### **PUBLIC HEARING III MEMORANDUM**

**528 Boylston Street**

Subject: 528 Boylston Street 40B Design Review (Memo #2)

**Re: Proposed Multifamily Residential Development Transportation Peer Review**

# Shadow Studies – June 21, Solar Angle 68°

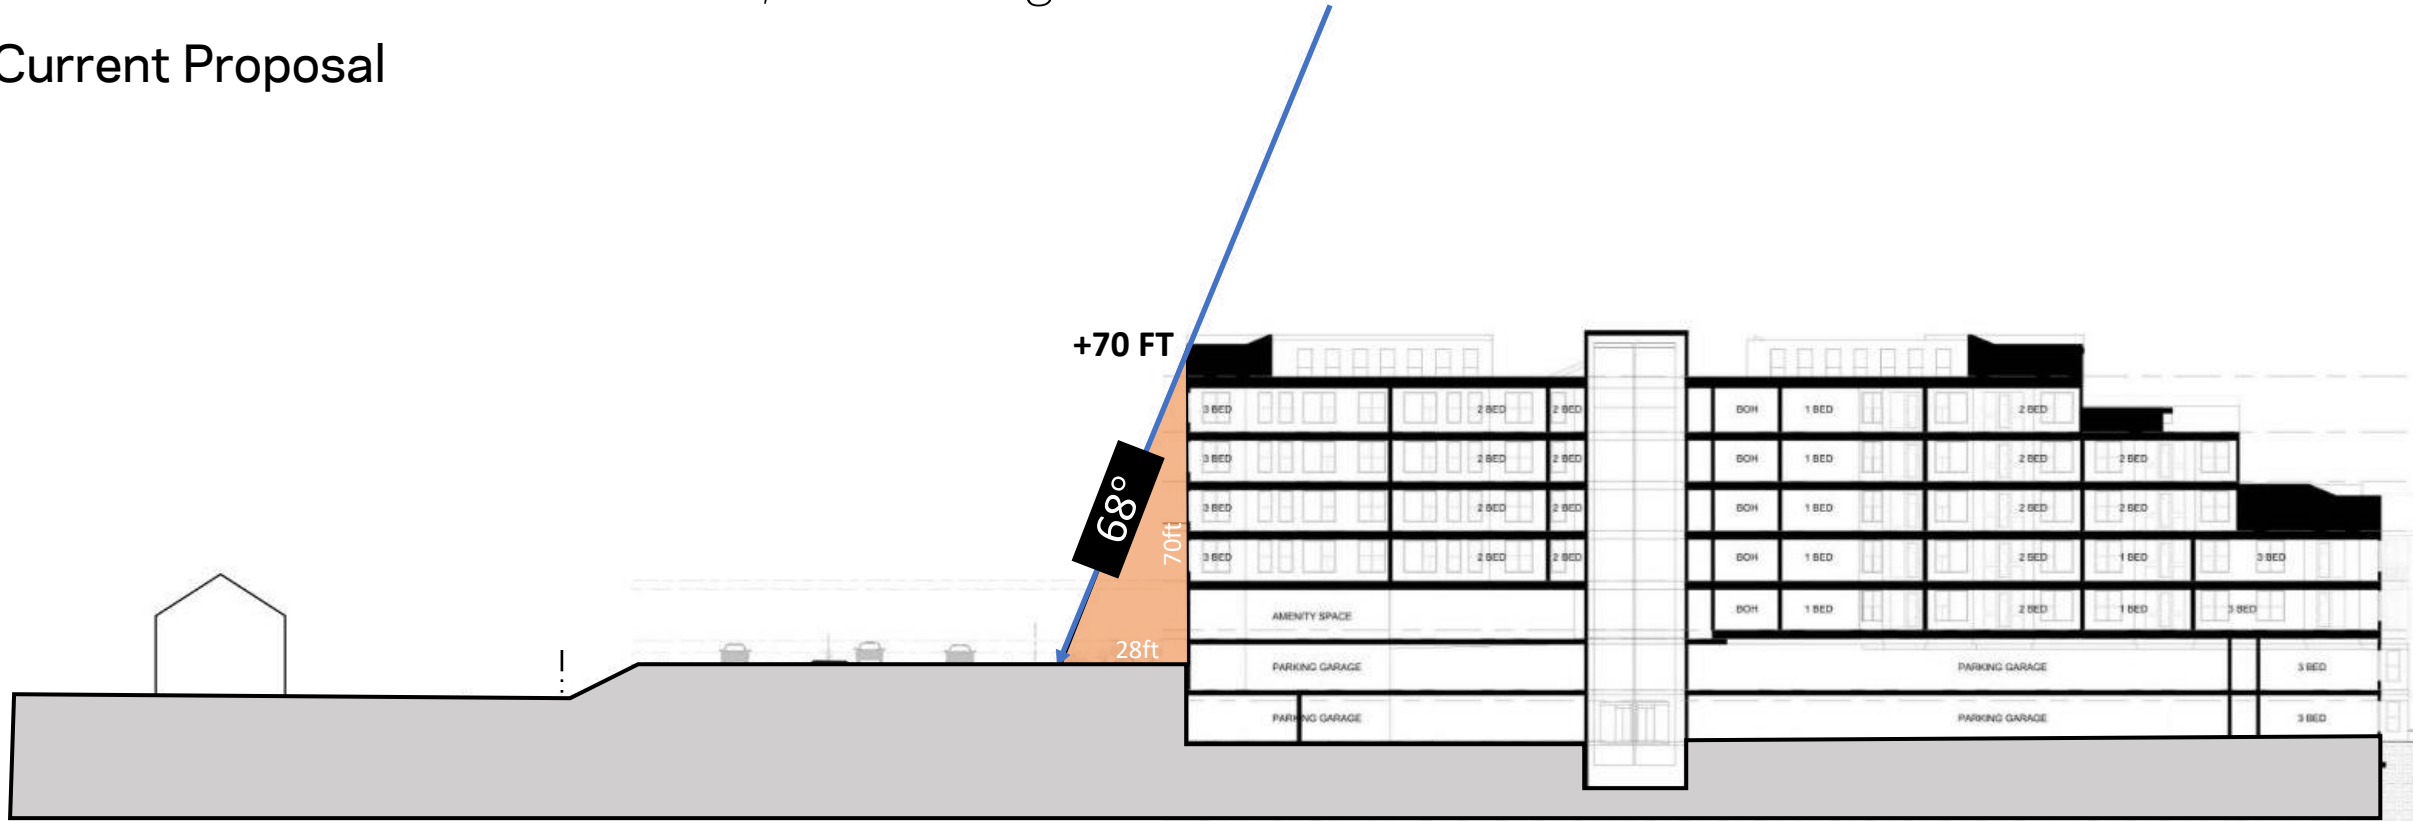
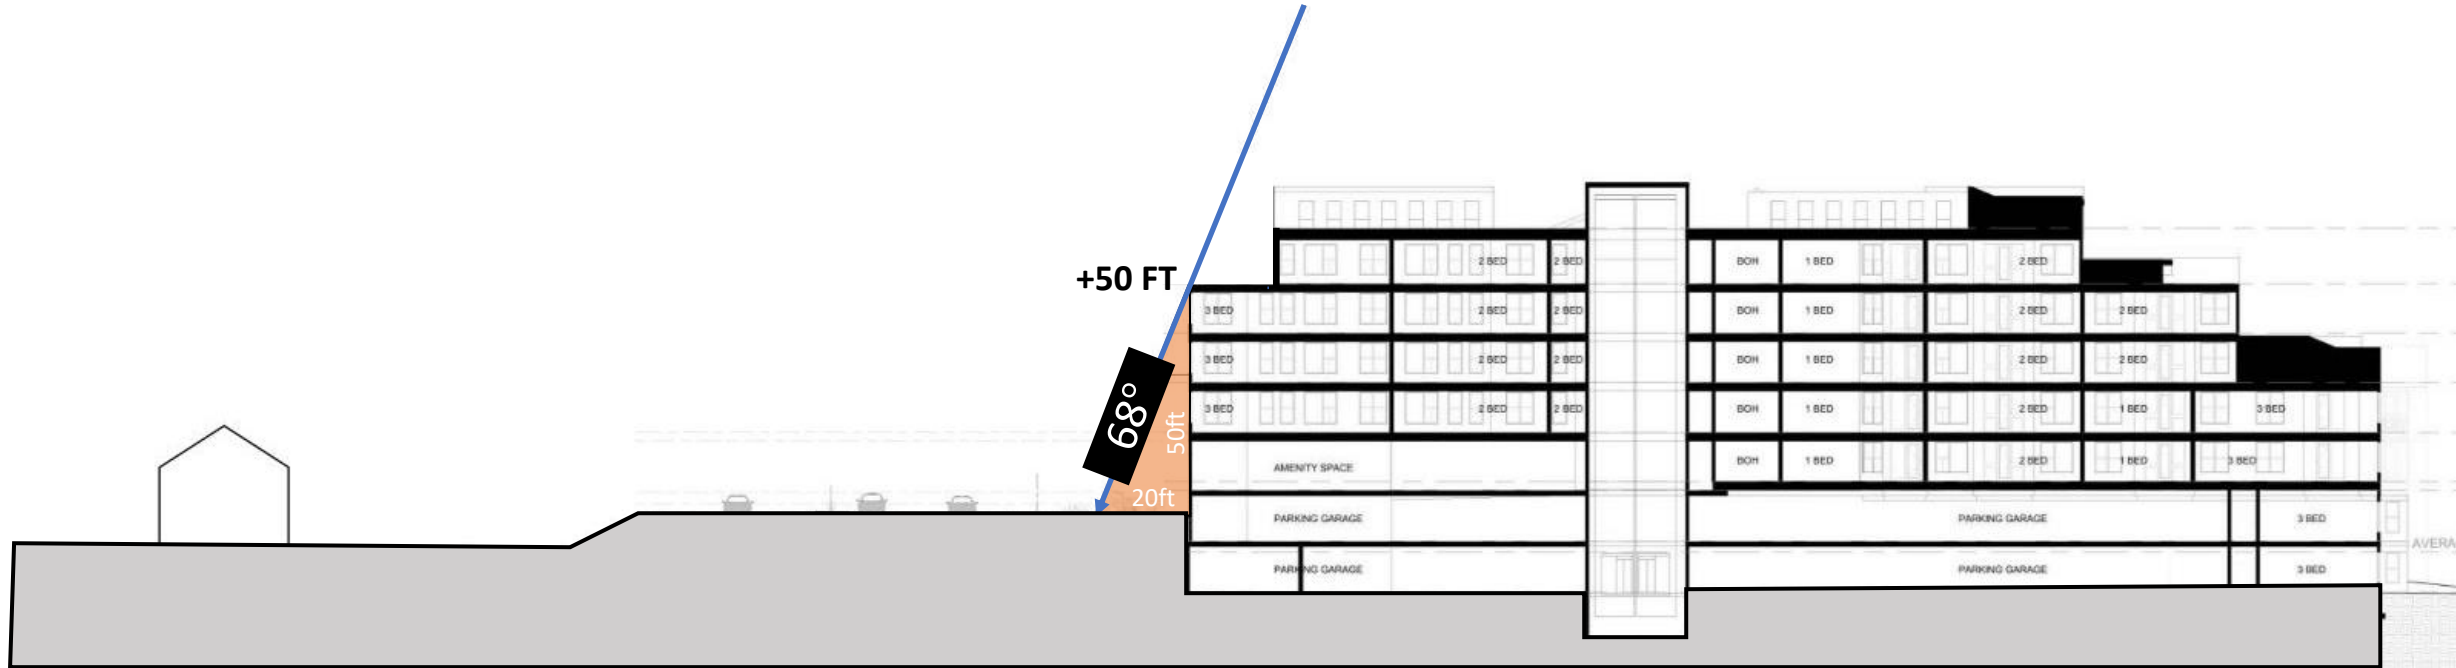
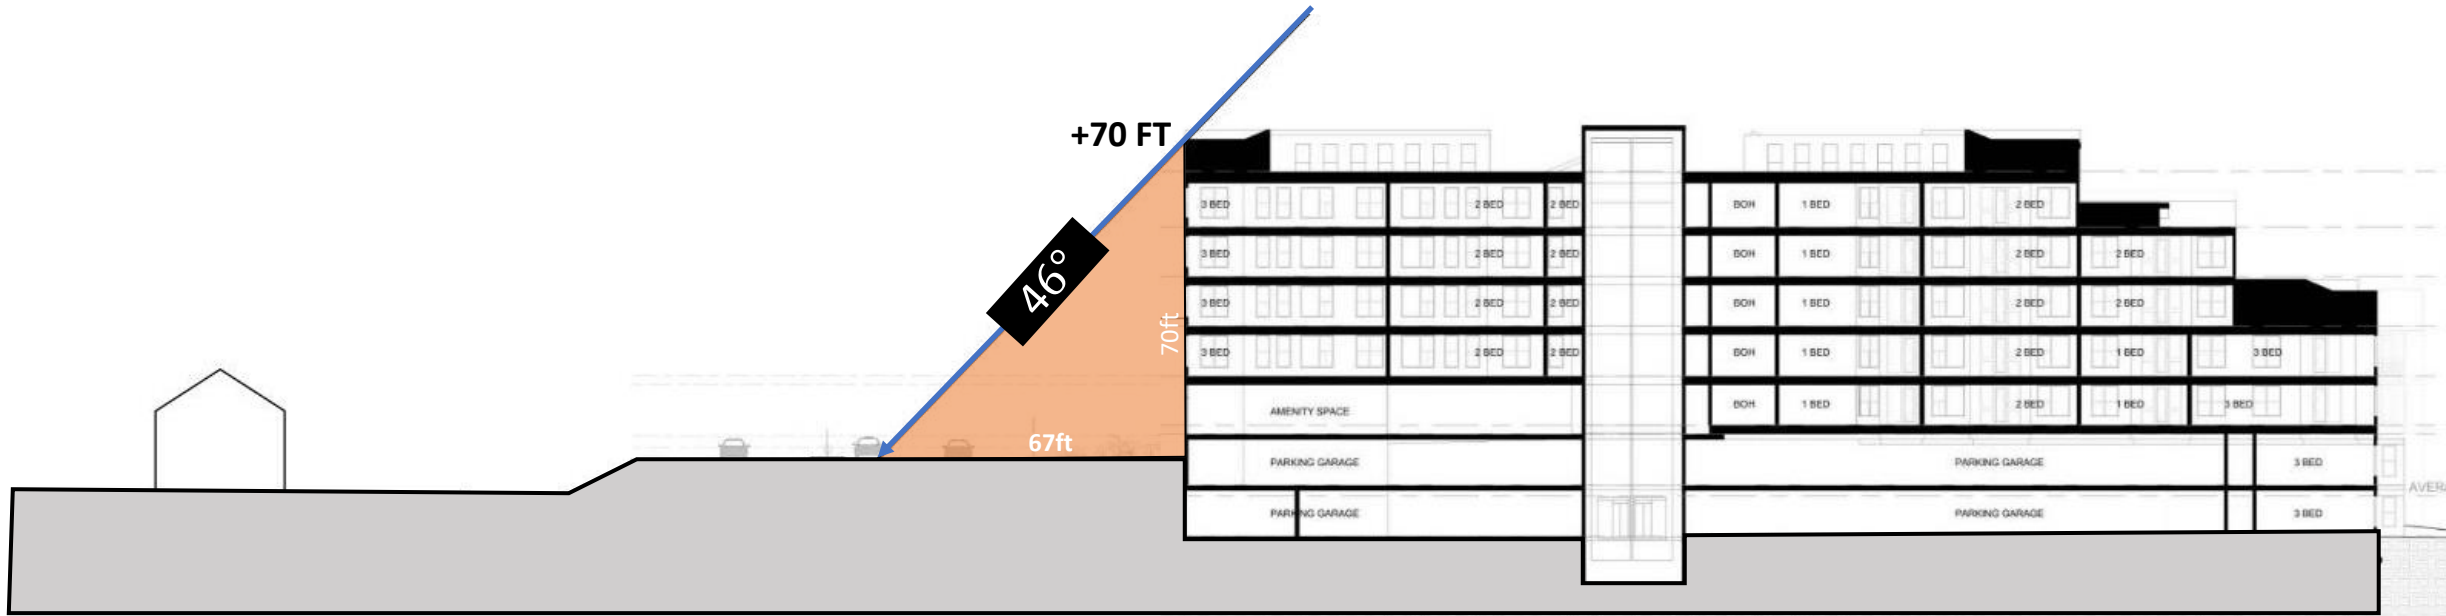
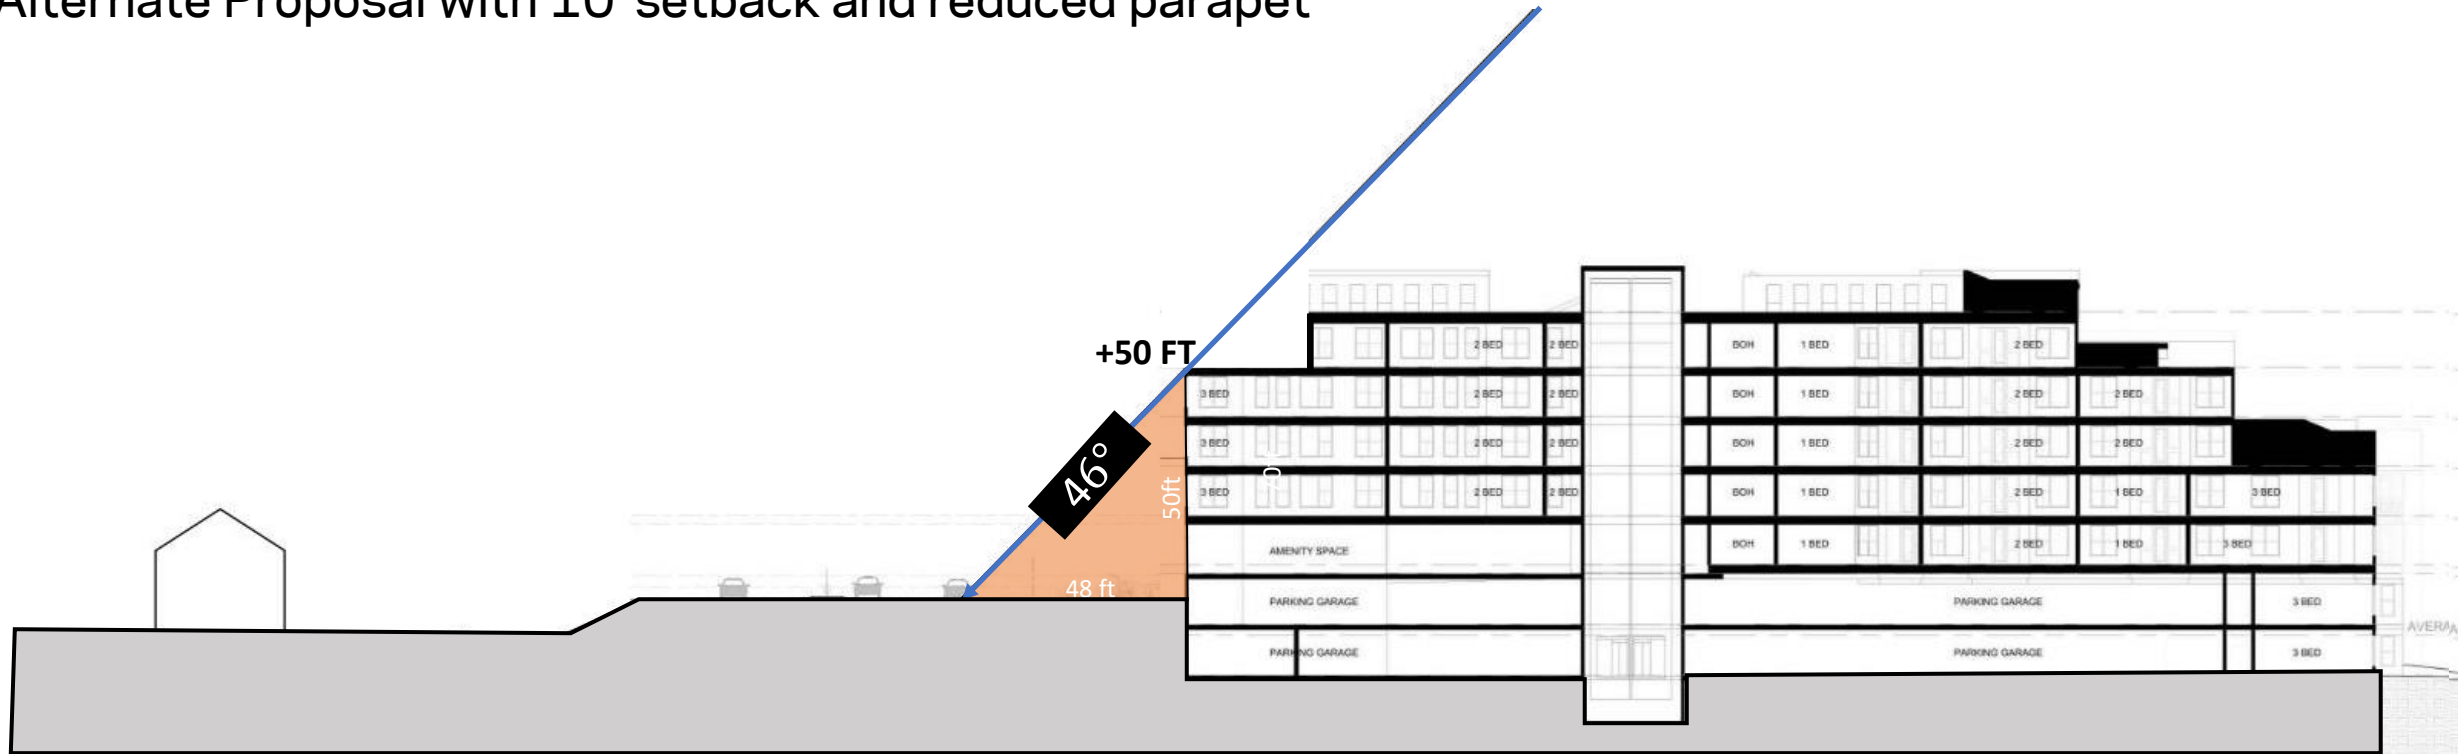
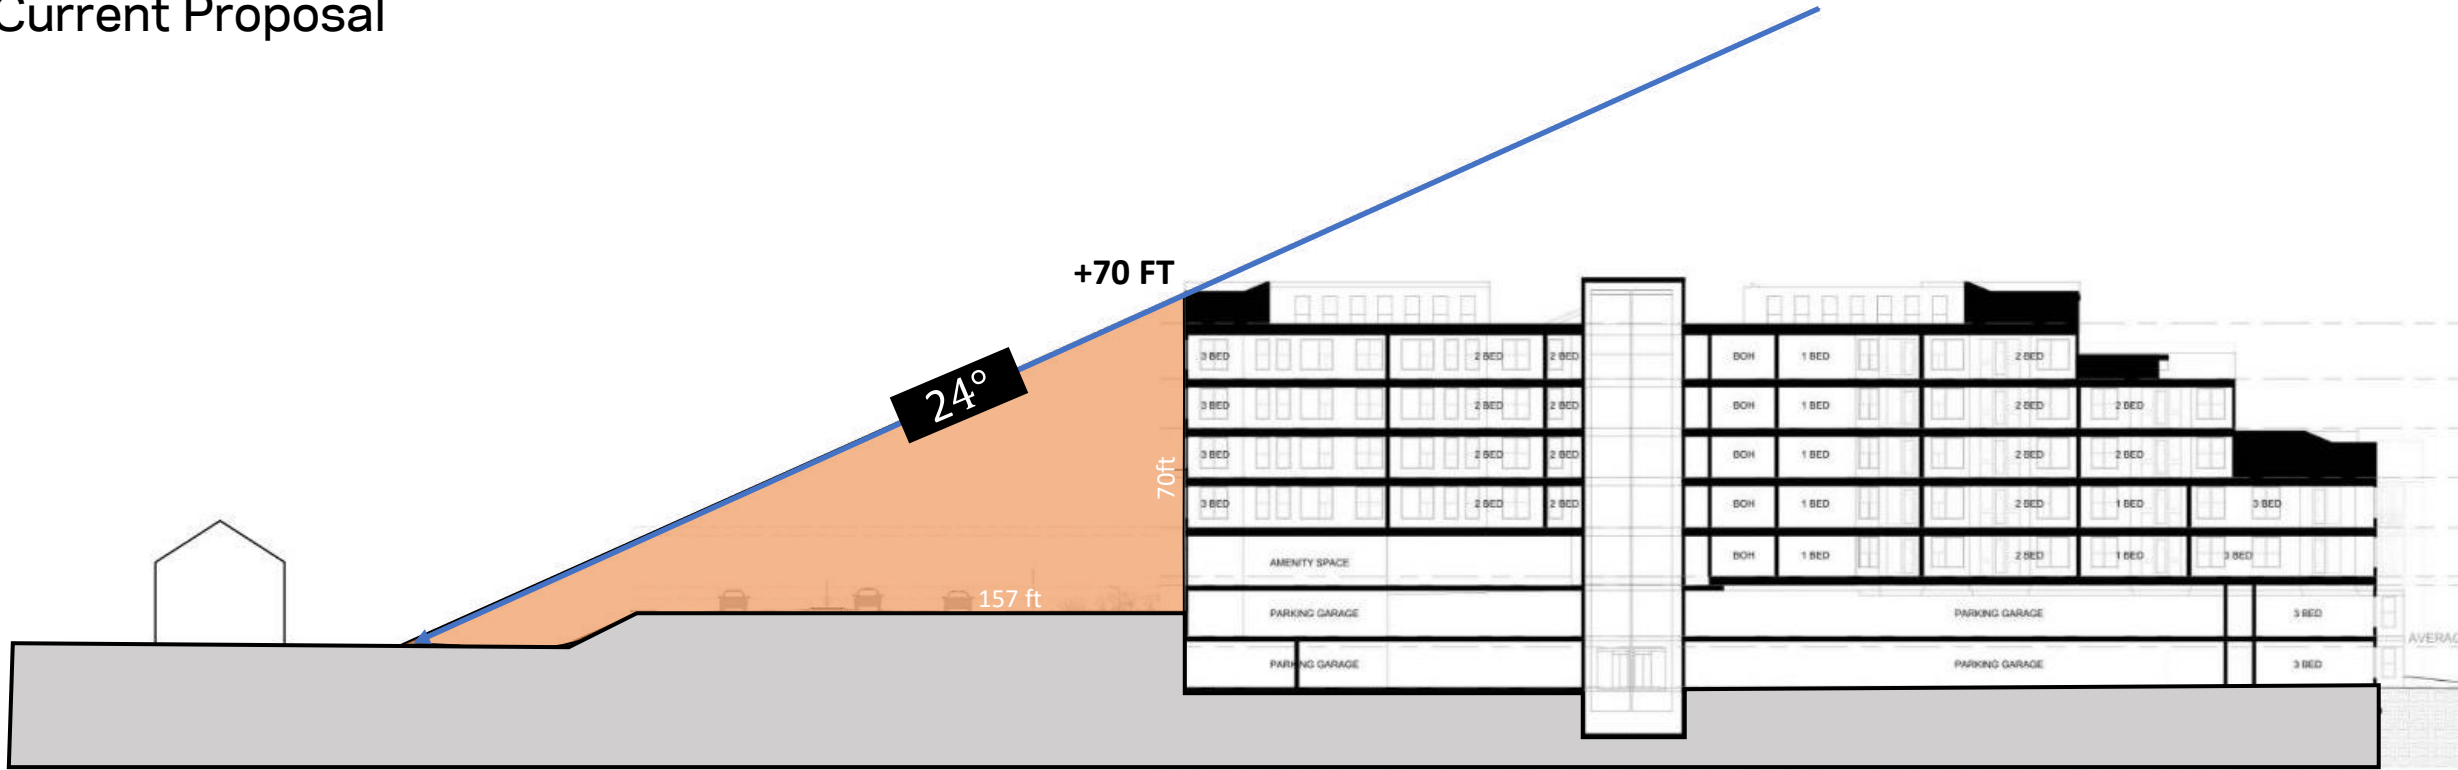
3. Reconsider the design of the gable roof parapet elements. While we understand that these are intended to screen rooftop condensing units, we have concerns about the added bulk (additional 10' of height) and shadow implications along Boylston Street. [\[see pages 22-30 in attached document\]](#)

Alternate Proposal with 10' setback and reduced parapet
